THE NATIONAL BOARD

NATIONAL BOARD SUBCOMMITTEE INSPECTION

MINUTES

Meeting of July 20th, 2016 Columbus, OH

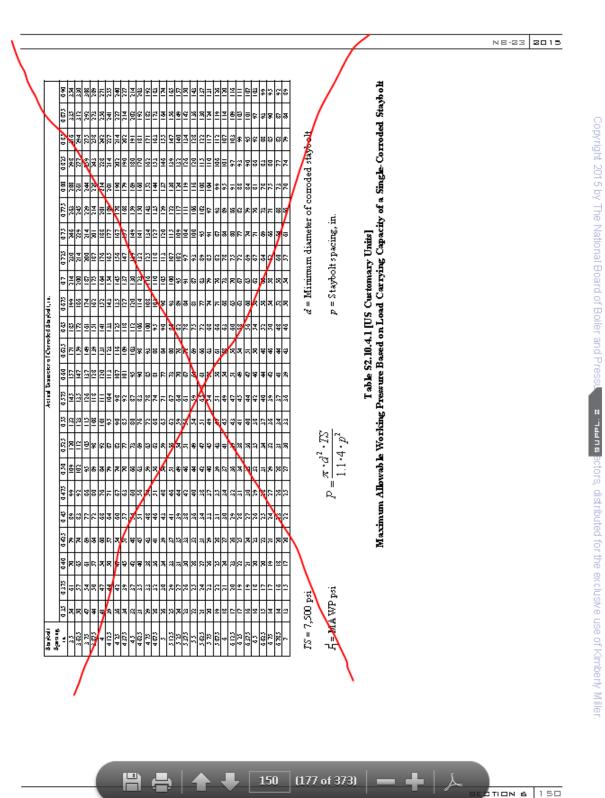
- 3.) In S2.10.6, the definition of 'hypotenuse' is unclear what the square-root symbol is supposed to cover.
- 4.) The values in table S2.10.4.1.a (imperial units, pg. 152) do not match what we originally submitted (what my records say) wrong #'s! I randomly checked a couple and I believe that our submitted table is correct, and the published table (don't know where it came from) is incorrect. I did a few random checks on the other 3 tables and they appear OK.

- 5.) We are inconsistent on the use of the symbol for multiplication. In the 4 tables above, we use the 'dot' symbol. In the equation on page 145, for S2.10.4.1.b, we use the 'cross' symbol in the denominator but nothing in the numerator. For S2.10.4, we use the 'cross' symbol. For S2.10.4.1.a, there is no symbol. They are all acceptable, but should be consistent.

7.) I've wondered, should we provide an example in the text for how to calculate MAWP for locally thinned areas, to help people understand how to use the text in \$2.6.3.3?
